NL-07-2346

**Vogtle Electric Generating Plant
Supplemental Information Supporting Acceptance Review,
Response to Request for Additional Information of November 20, 2007, and
Response to Request for Additional Information of November 29, 2007,
Regarding the Measurement Uncertainty Recapture Power Uprate Amendment**

- Enclosures: 1. Clarification of the Plant Design Changes and the Basis for Implementation
2. SNC Response to the November 20, 2007, NRC RAI Questions
3. SNC Response to the November 29, 2007, NRC RAI Questions

Fig. 1. Single-line diagram of Vogtle 500/230 kV.

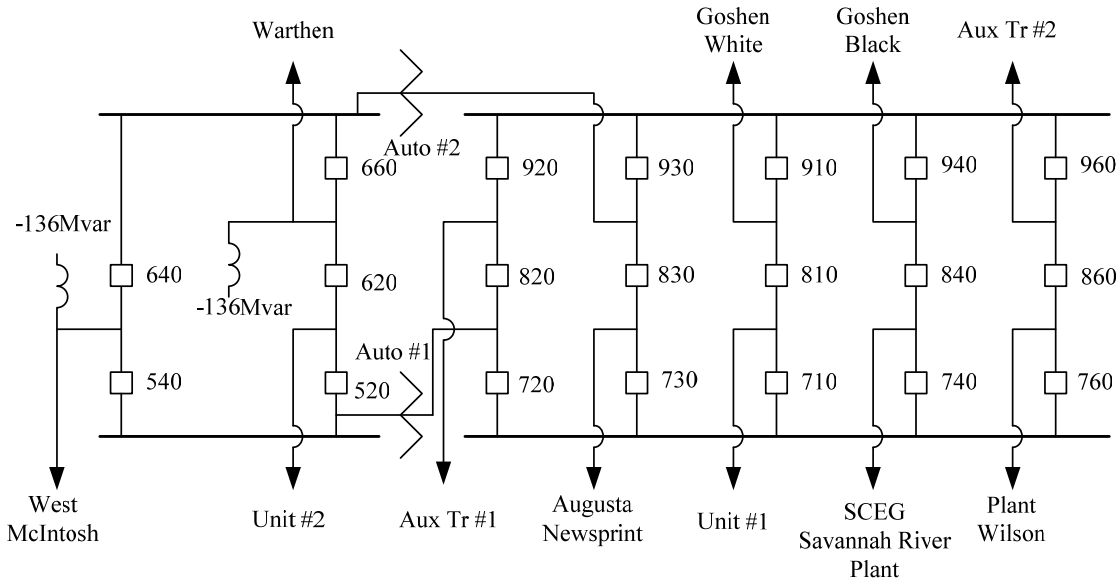
In Section V, Part D of the license amendment request, the licensee states that the stability impact of the power uprate was evaluated and concludes that the proposed electrical output uprate for the units will not cause any stability problems. Provide the grid stability study and discuss in depth the assumptions, methodology, cases studied, and evidence to support the conclusion.

The results show that with the proposed MW uprate for the Vogtle units, the critical breaker failure clearing time (BFCT) for the studied contingencies would be reduced by some degree, a reduction as much as 3.75 cycles from what was obtained with the existing MW outputs from Vogtle units. However, the current actual clearing time (CT) settings are much lower than the critical clearing time (CCT) obtained in the study. Therefore, the proposed MW uprate for Vogtle units will not cause any stability problems.

The breakers at Vogtle 500 kV and 230 kV substations are two (2) cycle IPO breakers. The single-line diagram for Vogtle 500/230 kV is shown in Figure 1.
